Tasks and questions from GRVA on cyber security proposal

(FIGIEFA and ETRMA comments are highlighted in green)

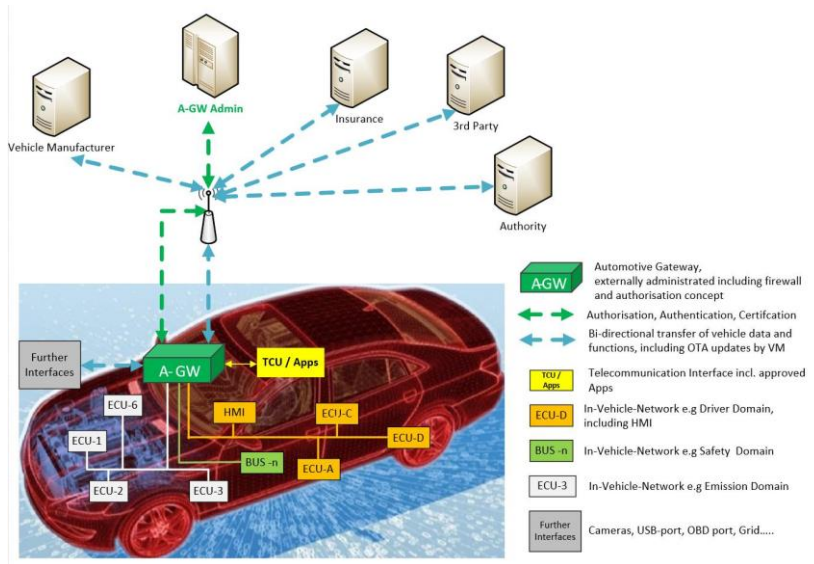
1. A Gateway *can* enable a safe & secure control of all interfaces of a vehicle! This holds true for interfaces to external communication partners (e.g. for V2X communication) as well as for the communication between applications in the vehicle and the vehicle's core systems (e.g. the ECUS or the HMI). However, an interface may be defined by national or regional legislation, so this Gateway may be required to support the functional requirements of a mandated interface for authorized parties.

2. As the trust model is technology neutral, a UN regulation should define the *functionality* of such a gateway, but not its very detailed technical specification. Additional functional requirements may be defined by national or regional legislation.

3. By using a common protection profile for the trust model including the gateway, the vehicle manufacturer stays free in the technical design as long as this design meets the protection profile. The protection profile can be checked by type approval authorities

To do this, the Gateway features the following basic security functionalities:

- a. The Gateway verifies the identity of the calling system, may it be an electronic traffic light that sends a "Stop" signal or an internal application that requires a Diagnostics trouble code. "Who is calling?". This is usually realized by use of electronic certificates.

- b. After a successful identification the Gateway determines what the caller "wants" (e.g. what function should be triggered or what value should be read from the car) and if the caller is generally entitled to do this according to the internal authorization concept.

- c. As a final check prior to the execution of the request the Gateway checks if the command is allowed in the current state of the car. If the car's Bus system is currently already flooded with requests with a higher priority the request could be either queued and thus delayed, if the car is driving and the request can only be executed without risks in a parked state then the request would be declined for now with a related response to the caller.

Note: In some architectural designs, some or all of these concepts these functionalities are realized in subsystems called "Firewall" or "Hypervisor". The names might vary, the tasks are the same. The above description is purely functional, pure software and doesn't prescribe any hardware implementation details.

The picture hereunder (on the next page) shows the Gateway in its role as a communication shell around the car's systems for external as well as internal calls:
